APPLICATION NO.	FILING DATE	FIRST NAMED INVENTOR	ATTORNEY DOCKET NO.	CONFIRMATION NO.
09/986,956	11/13/2001	Manuel Barbosa	1356-041	6385
25215 7590 08/21/2007 DOBRUSIN & THENNISCH PC 29 W LAWRENCE ST SUITE 210 PONTIAC, MI 48342			EXAMINER NGUYEN, XUAN LAN T	
			ART UNIT 3683	PAPER NUMBER
			MAIL DATE 08/21/2007	DELIVERY MODE PAPER

**Office Action Summary**

## DETAILED ACTION

FIG 1

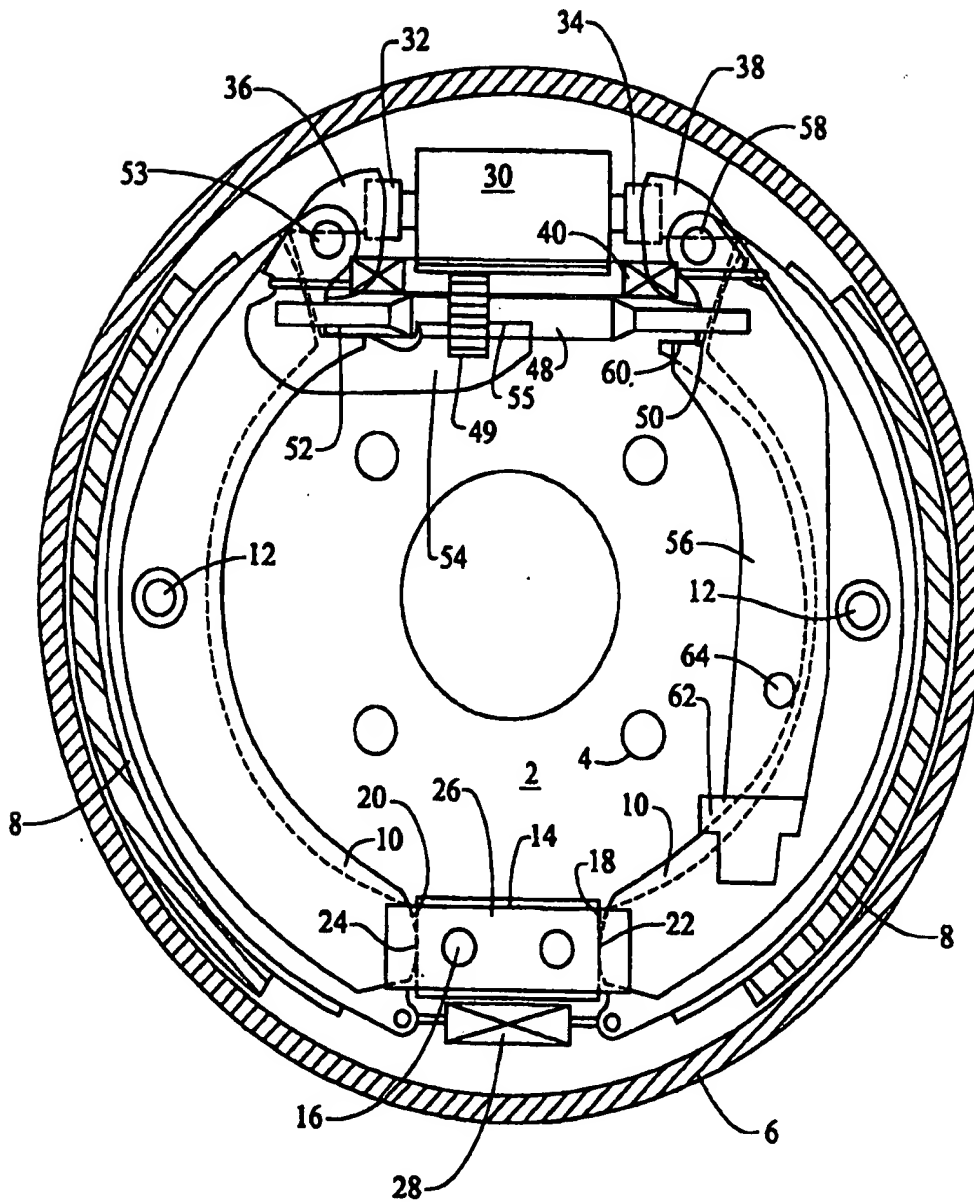
1. The drawings were received on 6/29/07. These drawings are not approved.
2. The drawings are further objected to under 37 CFR 1.83(a). The drawings must show every feature of the invention specified in the claims. Therefore, the claimed feature "a first spring for connecting the lower portion of the first and second brake shoes for maintaining contact of the first and second brake shoes against the surface of the lower actuating block" in claims 24 and 26 must be shown or the feature(s) canceled from the claim(s). No new matter should be entered. Please note page 4 of the specification, paragraph 16 where it states "A spring 28 is connected between the ends of the levers to hold ends 22 and 24 to surfaces 18 and 20."

NOT  
approved  
8/14/07  
XLN

FIG. 2

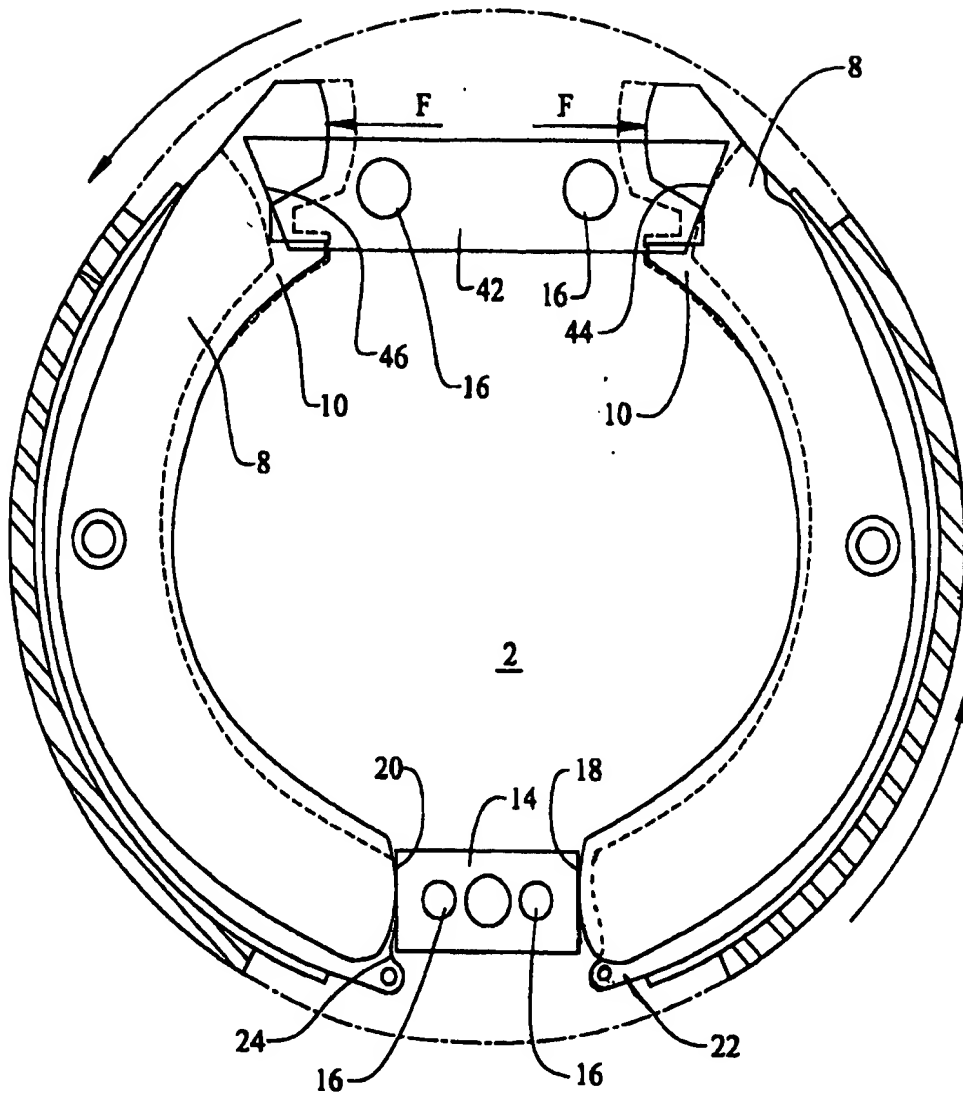
NOT  
approved  
XLW  
8/14/07
